PUD NO. 1 OF SKAGIT COUNTY
CAMPUS REPLACEMENT ADMINISTRATION BUILDING
PN 3675
June 22, 2023
ADDENDUM NO. 2

The following changes, additions, and/or deletions are hereby made a part of the project bid documents for the Campus Replacement Administration Building and shall have the same effect as if set forth therein.

SOIL PREPARATION SECTION - LAWN & PLANTING AREAS

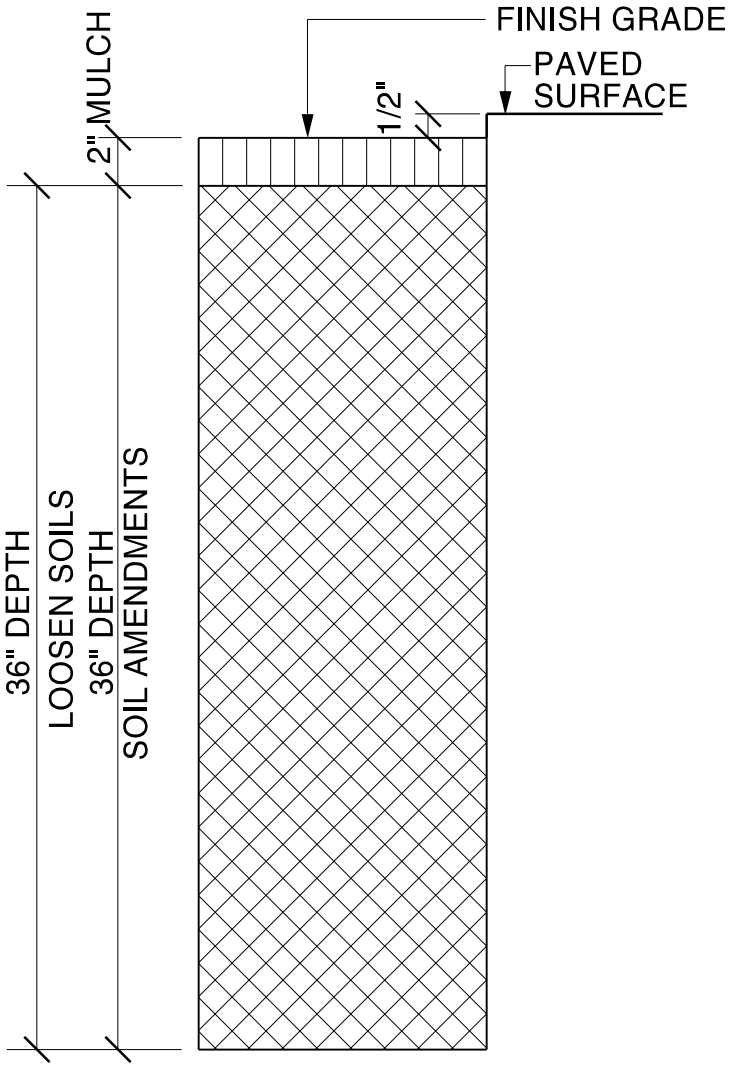
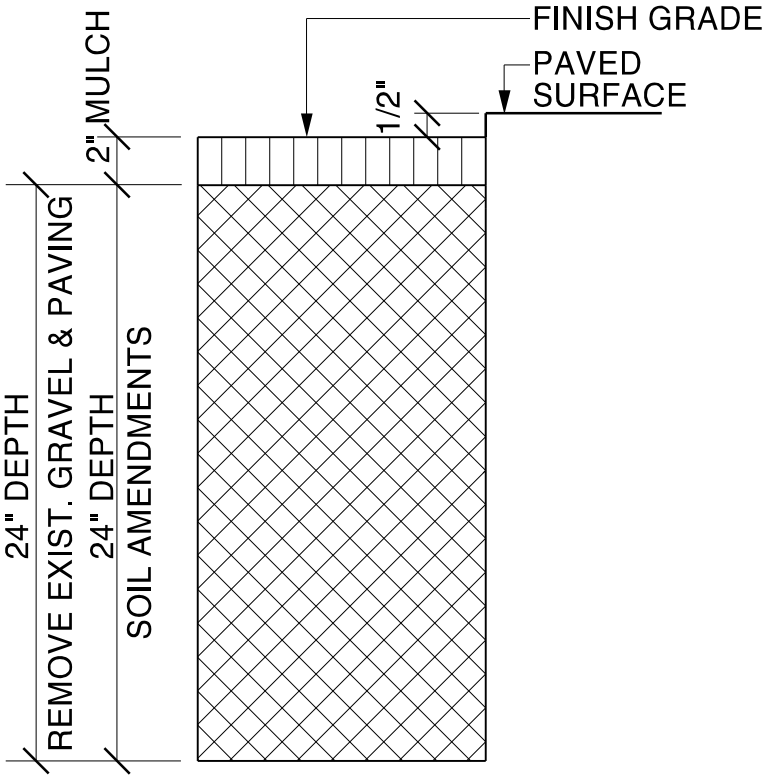
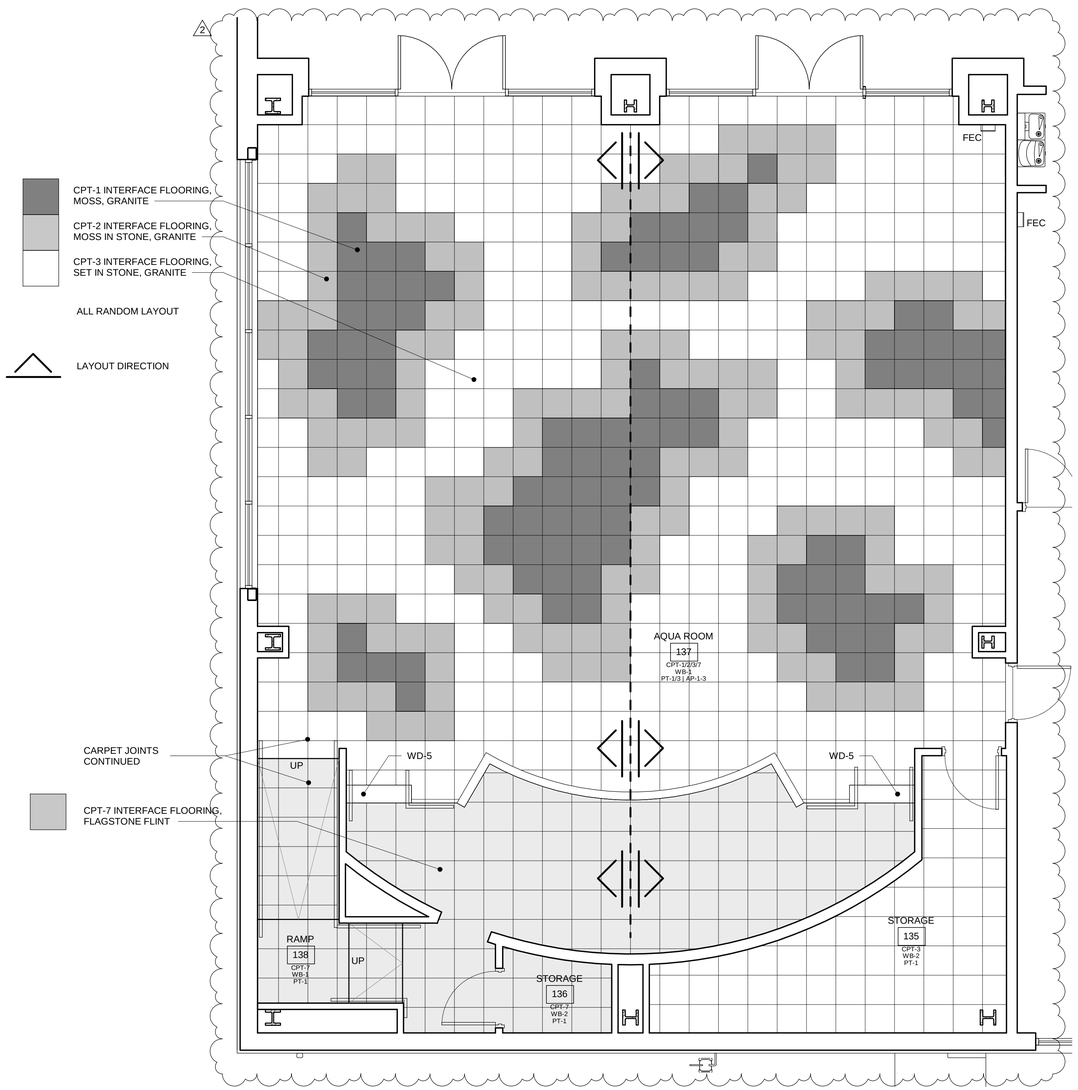
a. Add new attached detail #5 for soil preparation sections.

AQUA ROOM CARPET | SCALE 1/4" = 1'-0" | 9

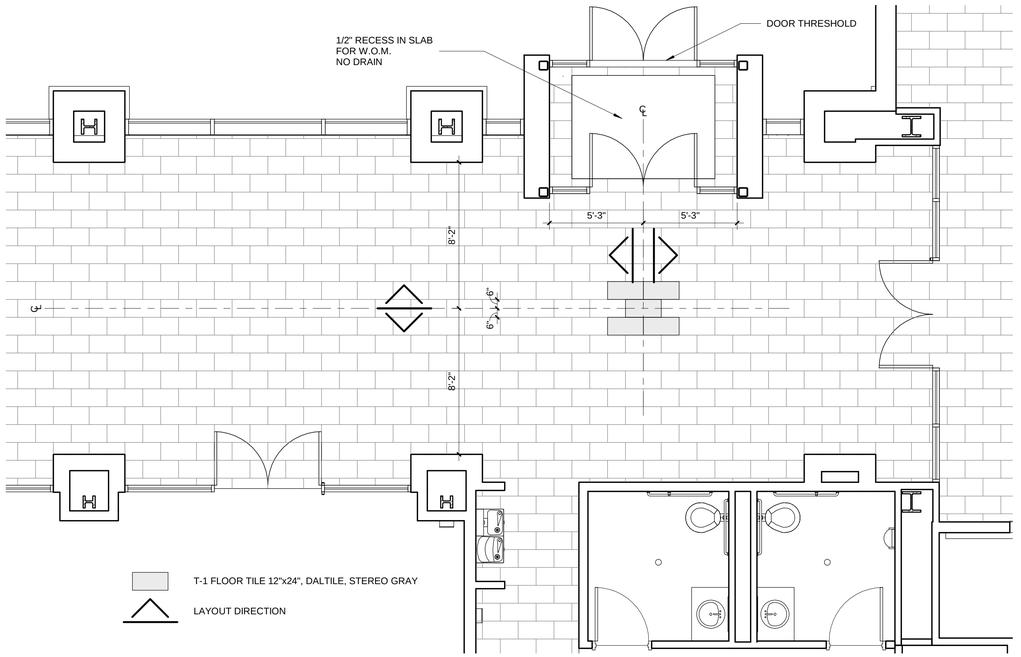
a. Per the attached sheet, details 3 & 9 were corrected to show the carpet tile sizes to be 19.7" squares instead of the previously shown 24" squares.

ELECTRICAL SITE POWER PLAN

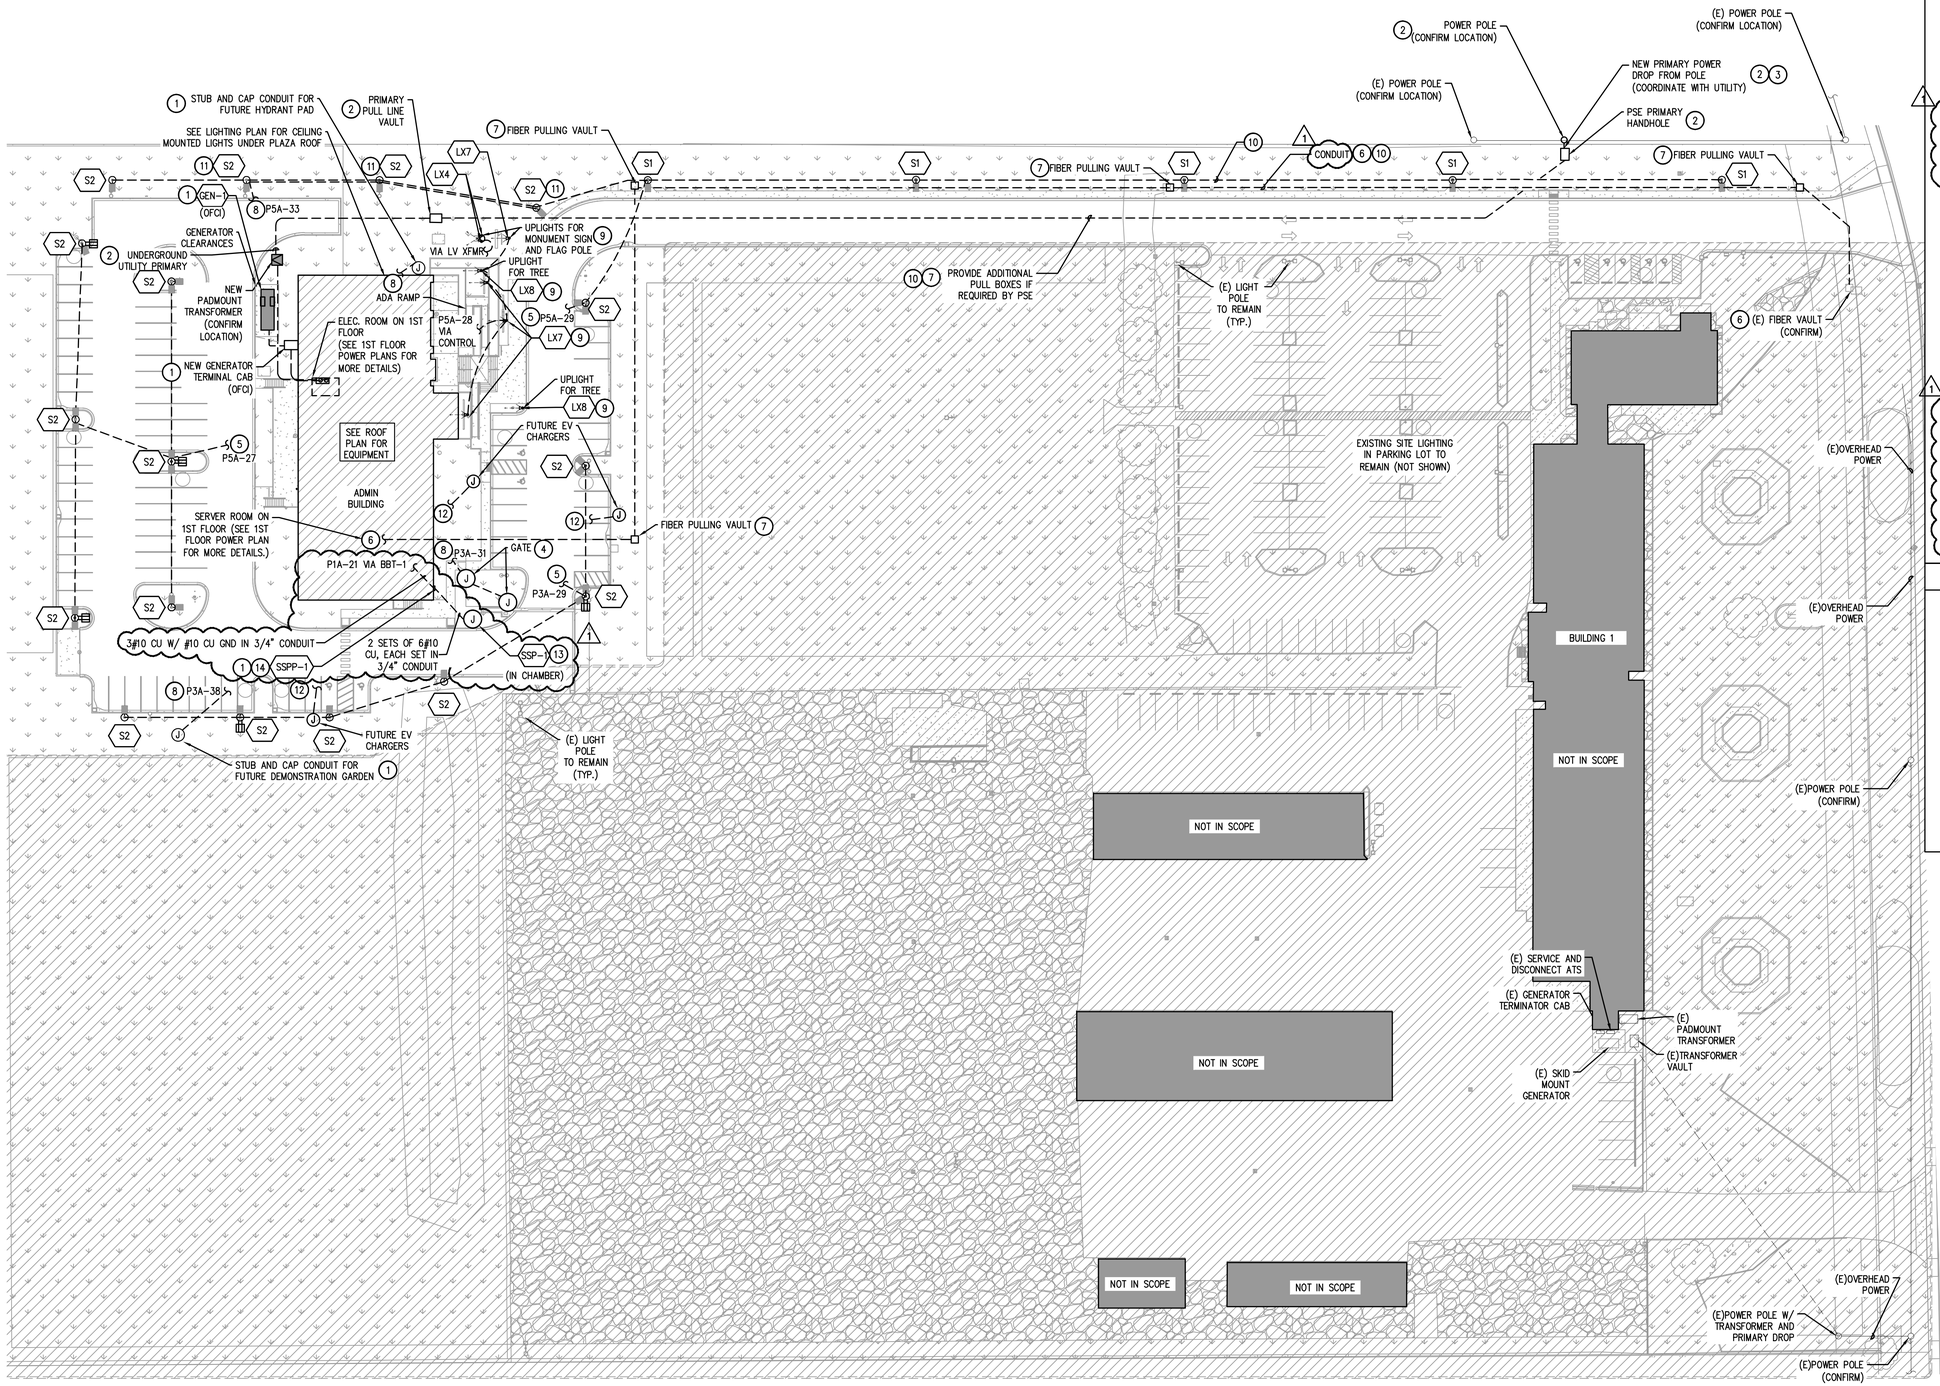
1. E1.00 – ELECTRICAL SITE POWER PLAN
   a. Change note #6 per the attached sheet.
   b. Add new notes 13 & 14 per the attached sheet.
   c. On the plan, add power connection and notes to the sanitary sewer pump per the attached sheet.
2. E2.01 - ELECTRICAL LEVEL 1 POWER PLAN
   a. Update Key Note 17 per the attached sheet.
   b. Add new Key Note 18 per the attached sheet.
   c. On the plan, add new callouts to the Server Room and Mechanical Room per the attached sheet.
3. E2.03 - ELECTRICAL ROOF POWER PLAN
   a. Update notes related to the GPS antenna per the attached sheet.
4. E5.02 – ELECTRICAL CONNECTION SCHEDULE
   a. Add new Other Equipment Connection Schedule per the attached sheet.
5. E6.02 – ELECTRICAL PANEL SCHEDULES
   a. Update diagram for Panel P1A per the attached sheet.
6. E6.03 – ELECTRICAL PANEL SCHEDULES
   a. Update diagram for Panel PG1A per the attached sheet.

SHEET NUMBER:
T2.01

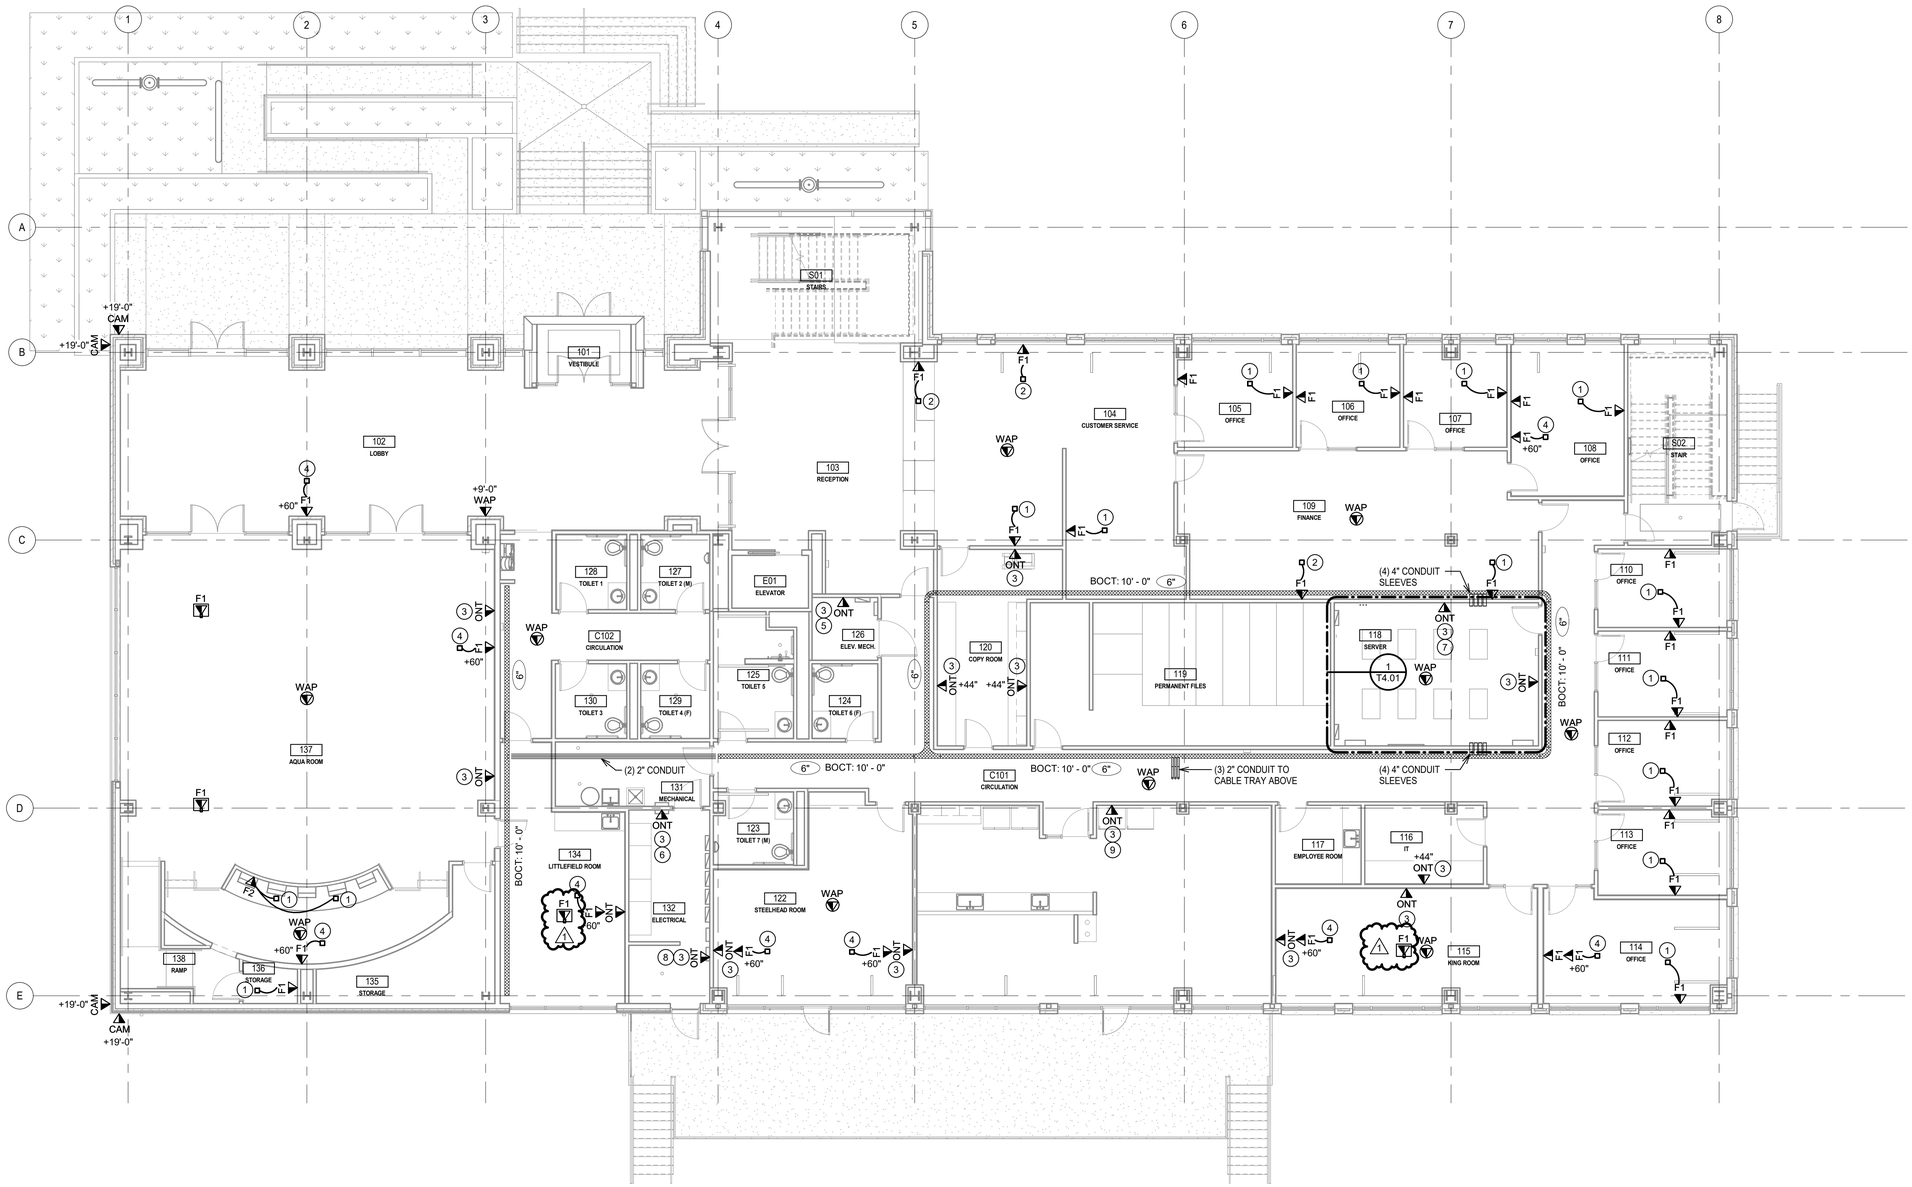
1. T2.01 – LEVEL 1 FLOOR PLAN - TELECOM
   a. Add F1 floor box callouts to King Room 115 and Littlefield Room 134 per attached sheet.
2. T2.02 – LEVEL 2 FLOOR PLAN - TELECOM
   a. Add F1 floor box callout to Coho Room 202 per attached sheet.
